**MAPLE SWAMP WETLAND MITIGATION SITE
ANNUAL MONITORING REPORT – YEAR 1**

MEMO
Lindsay Crocker, DMS

Re: Maple Swamp Wetland MY1 (email dated 12/21/22)
DMS Site #100190, Contract #200206-01

DMS received the MY1 report 12/1 and offers the following comments:

FIGURE
1

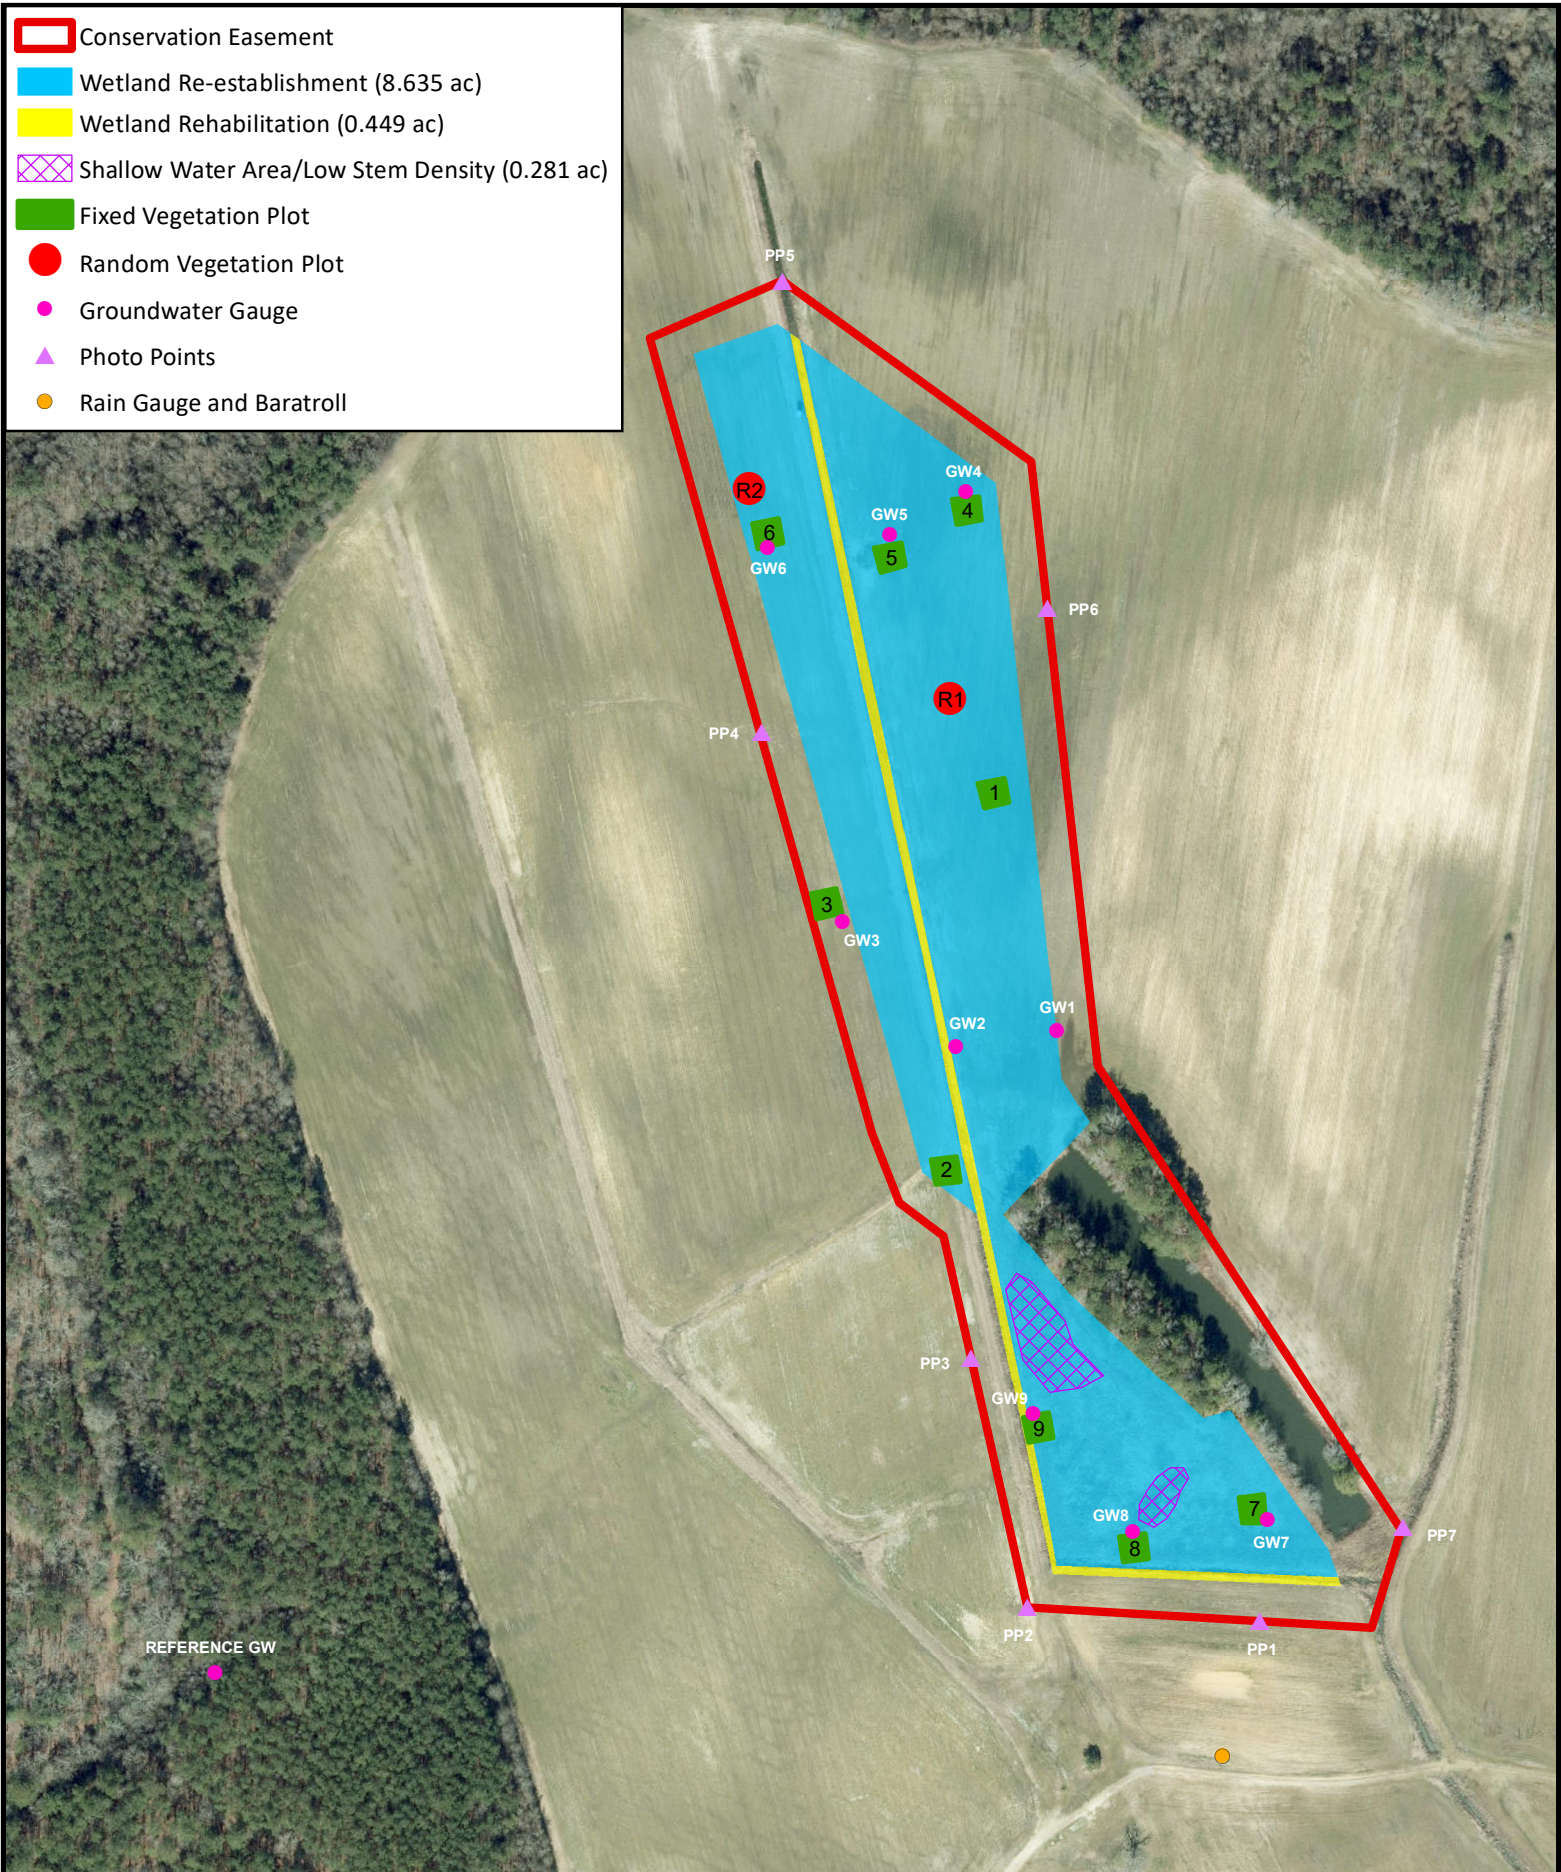
- The report describes a reference gage which provides helpful context for the site hydrology. Please provide this gage graph, hydroperiod (%) on the gage results table, and show location of reference on CCPV or separate map.

2. All areas indicated on the visual assessment tables must appear on the CCPV and GIS files indicating location/extent must be submitted.
[This has been updated and shallow water areas are shown on the CCPV with more clarity.](#)

The reference gauge groundwater graph is provided in Appendix C after well 9. The longest recorded hydroperiod for MY1 has been added to Table 9 in Appendix C. The reference gauge location is shown to the southwest of the Site on the CCPV.
